Access Compliance Report

Public Rights-of-Way

(Pedestrian Signals)

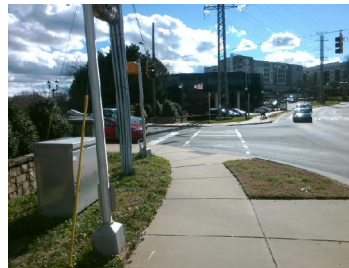
Surveyor Notes: OUT OF SERVICE

PROW/ADA: TMUTCD 4e.08, R404.2

Possible Solutions: Replace Signal Push Button With APS Button on New Post. Remove & Relocate Sign.
